**Canadian Nuclear Laboratories,
Douglas Point Waste Facility**

Application to amend the waste facility
decommissioning licence for the Douglas
Point Waste Facility

Why Due Diligence Needed as per Potential Adverse Environmental Effects in Phase 3 of Douglas Point Waste Facility Decommissioning

submitted by Dr. Sandy Greer, PhD © November 2020

Figure 3: Historic Site Drainage Areas (GOLDER 2011d; Figure 5.4.3.2)

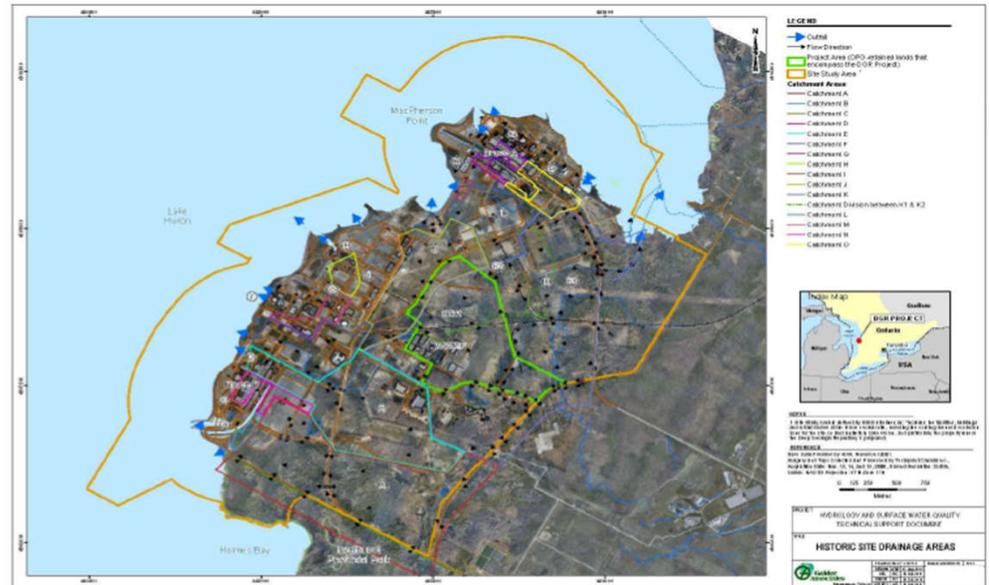
The interconnections of water pathways above show they go beyond political boundaries, to indicate we, in fact, live in bioregions not limited by municipalities.

The above image is from the “Hydrology and Surface Water Quality Tech. Support Document prepared by Golder 2011 to show “Historic Site Drainage Areas” for the OPG DGR.

It provides a clearer understanding of drainage than line drawings and flow diagrams in the CNSC EPR re. the DPWF Inactive Drainage System. Groundwater and storm runoff discharge into Lake Huron at six discharge points.
